PROJECT: NHPP-0002-06(022)/107209301 - Lee

SECTION 904 - NOTICE TO BIDDERS NO. 6694

SUBJECT: Additional Detail Sheets

PROJECT: NHPP-0002-06(022) / 107209301 – Lee County

SIGNAL AHEAD FLASHER ASSEMBLY
WITH 4" POST - 15'-0" LONG

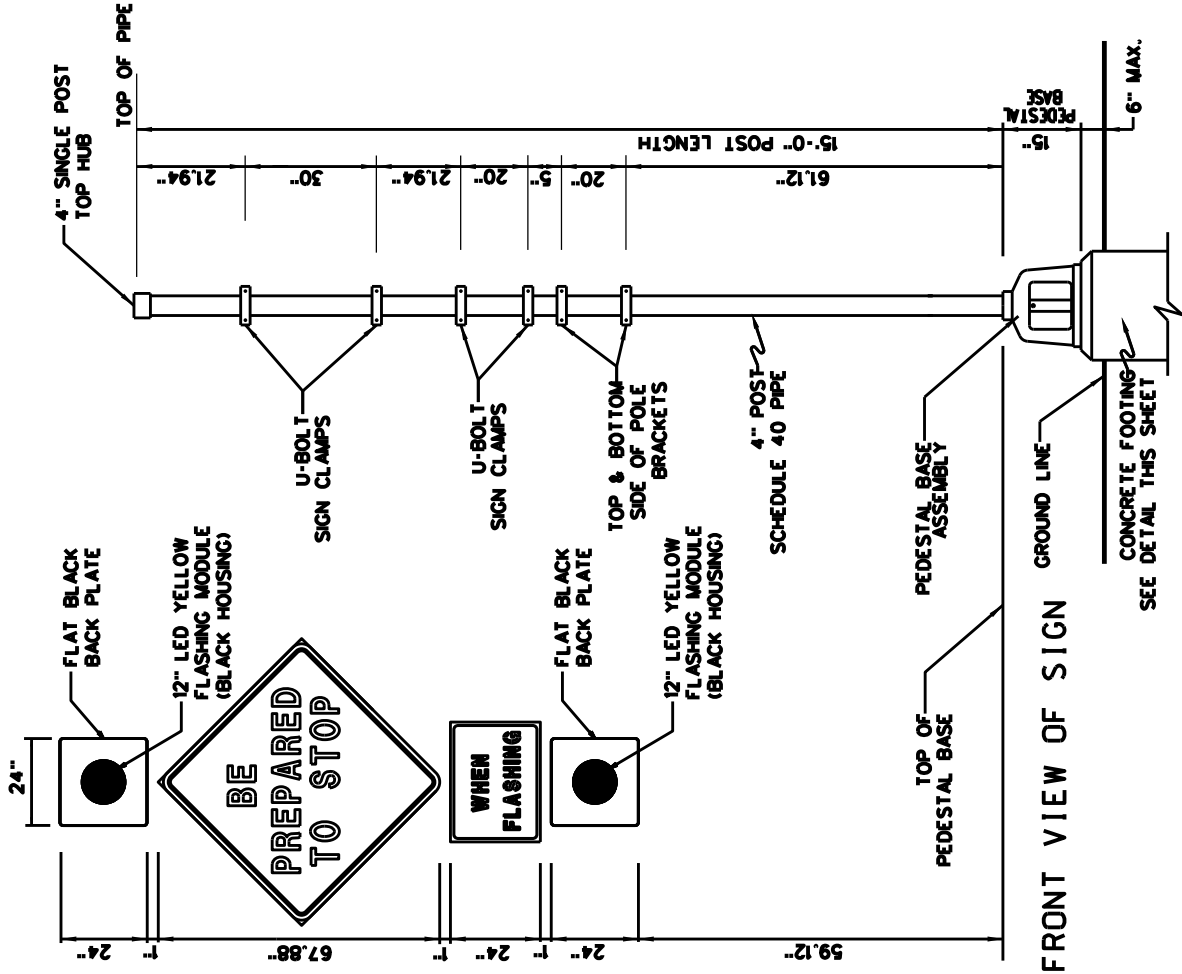
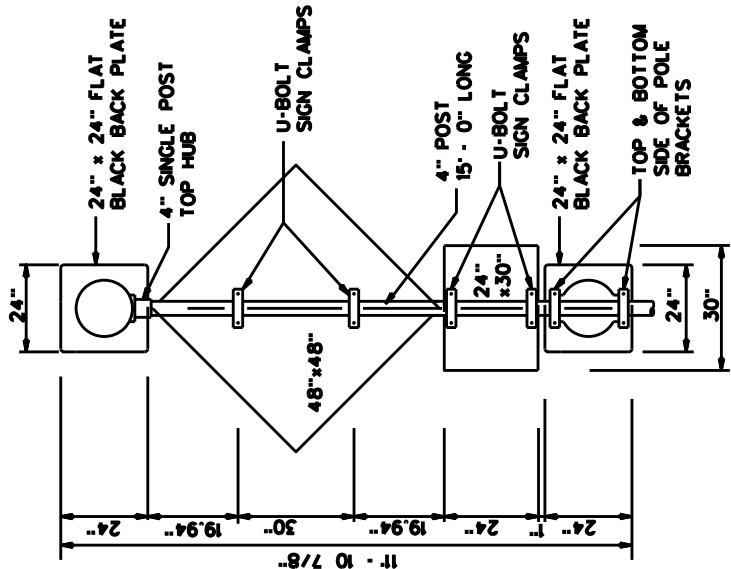
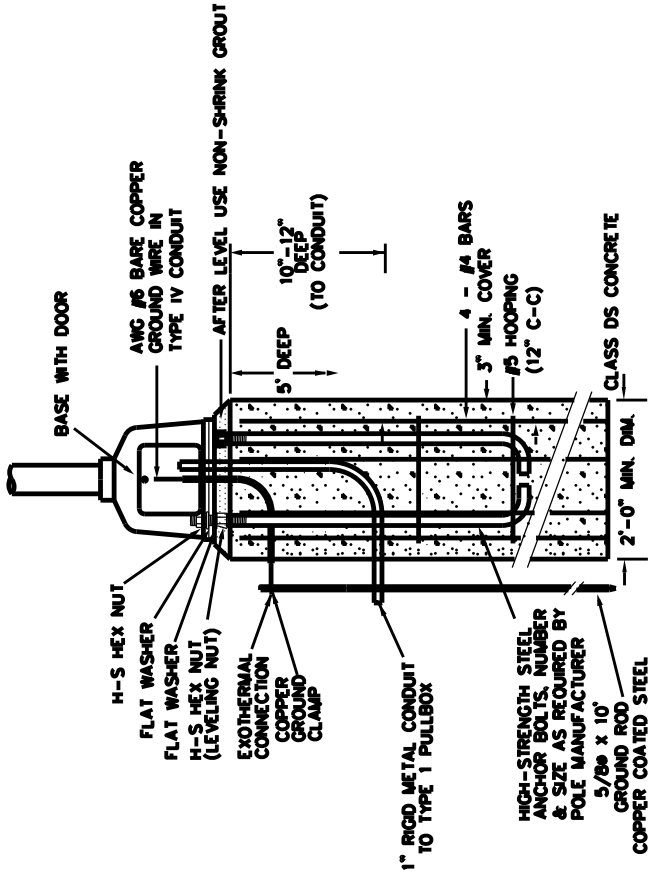
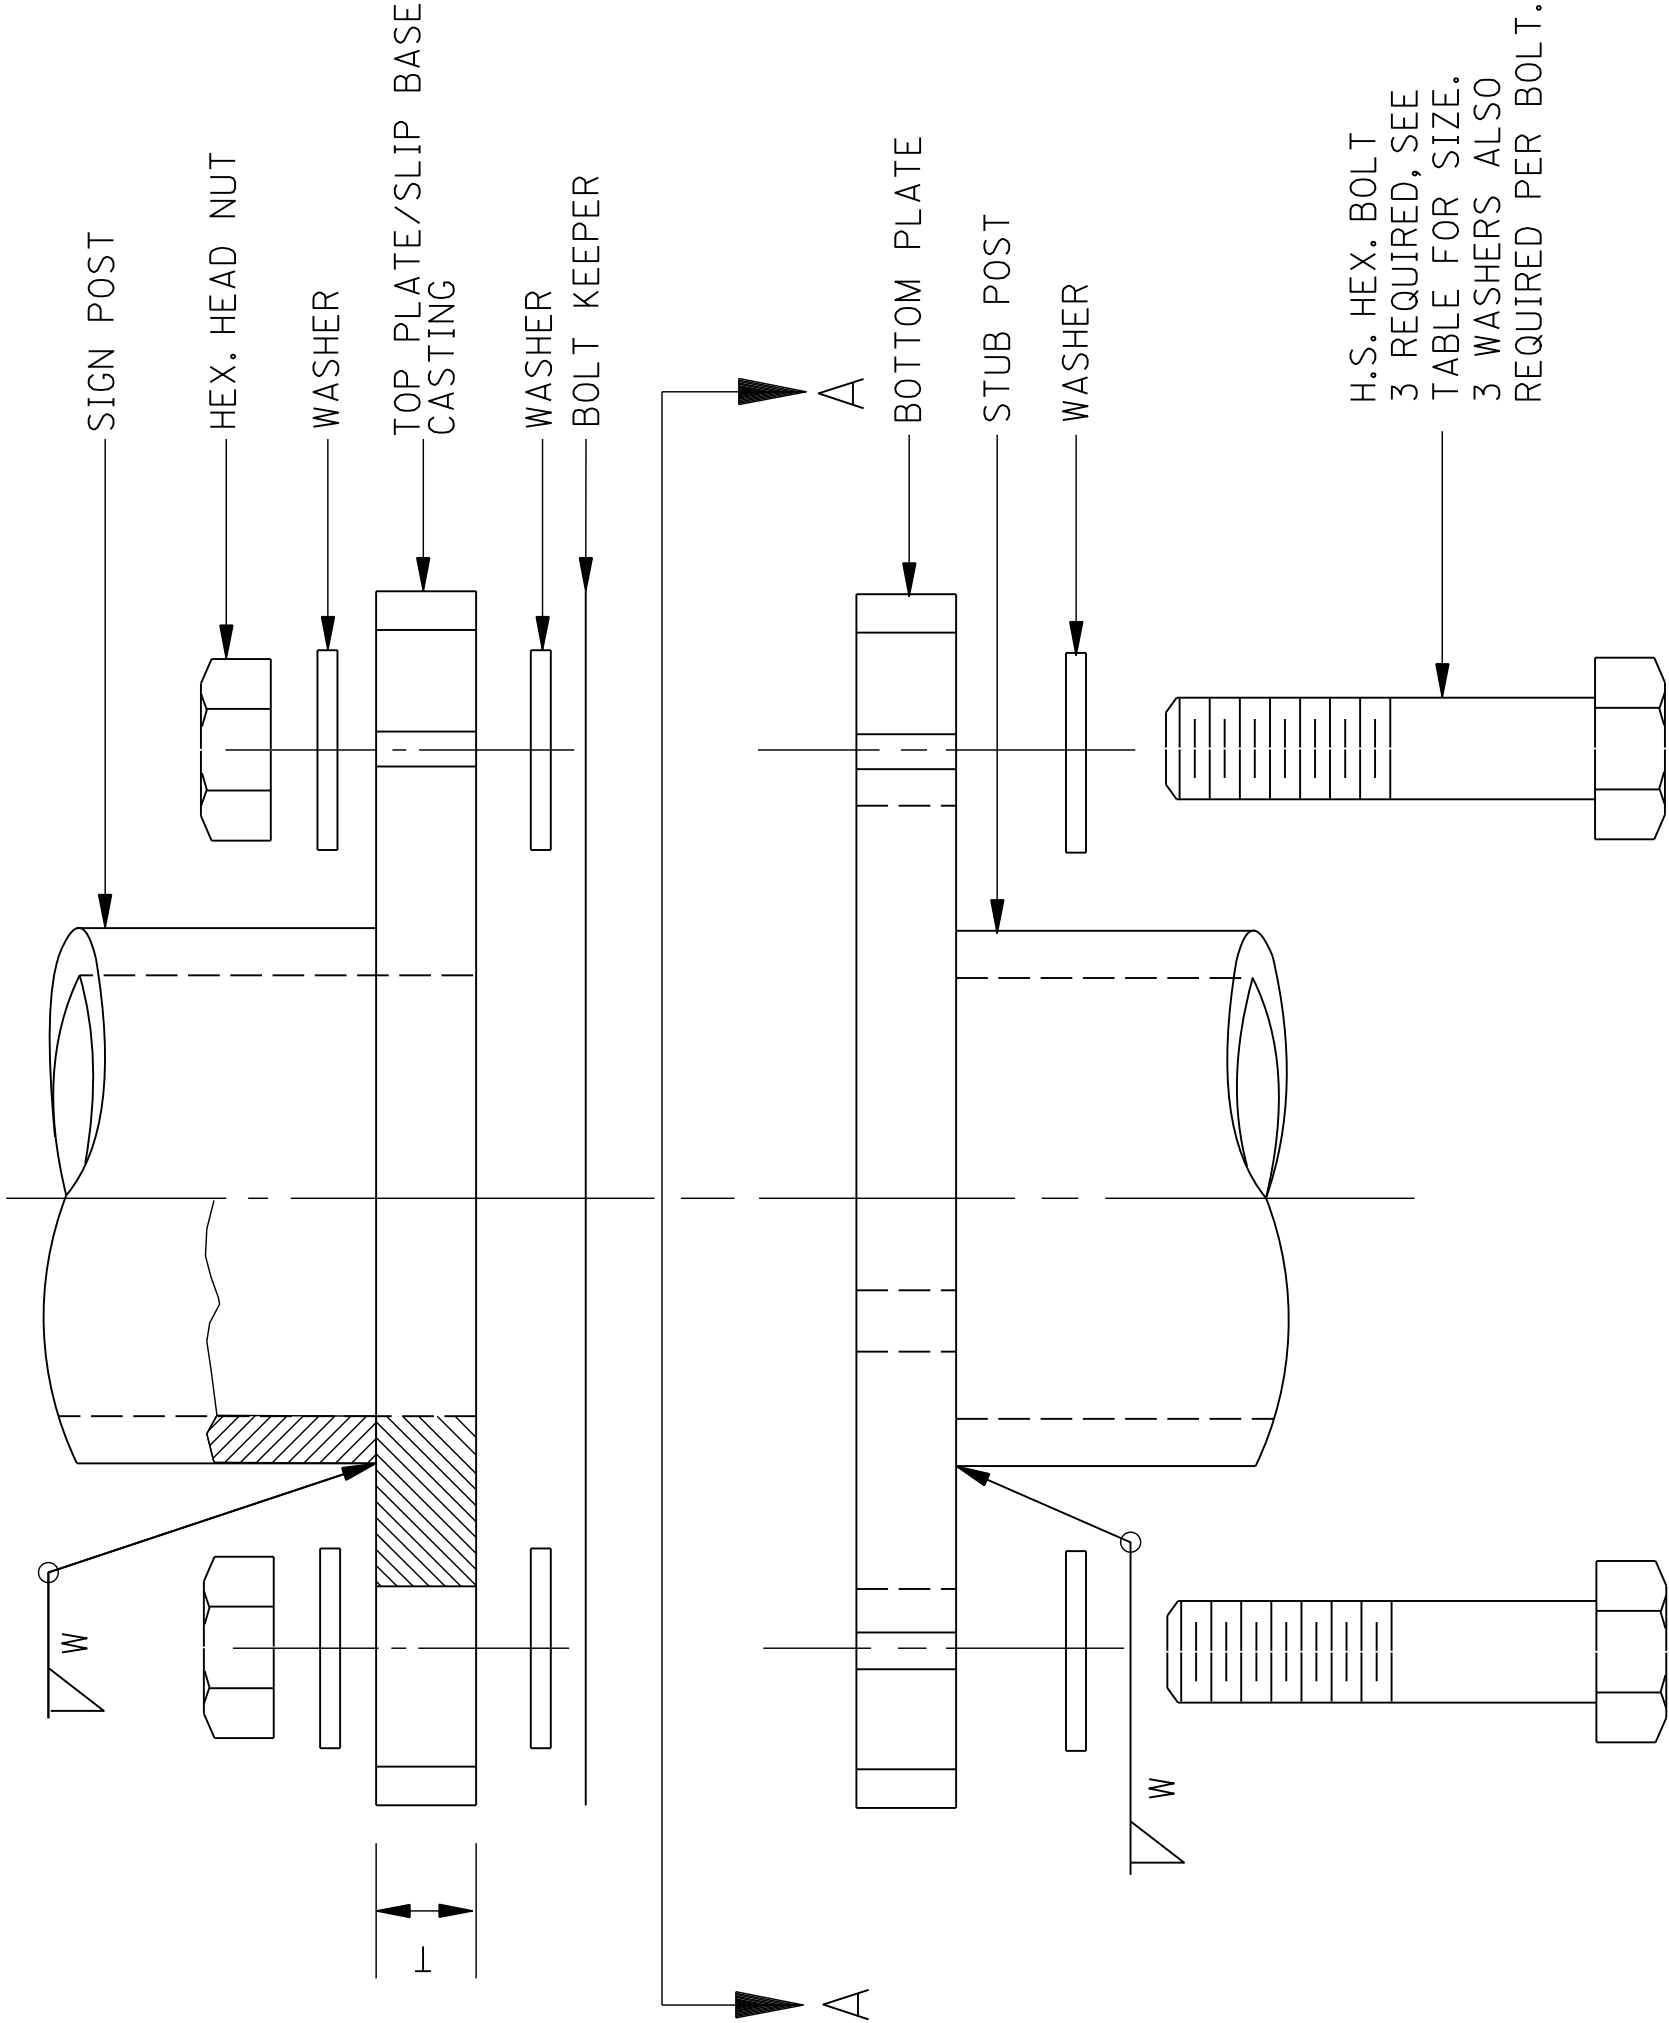
The Bidder is advised that Working Sheets SSD-1 and SSD-4C were inadvertently left out of the Contract Plans. The following drawings attached hereto shall govern appropriate items of required work.
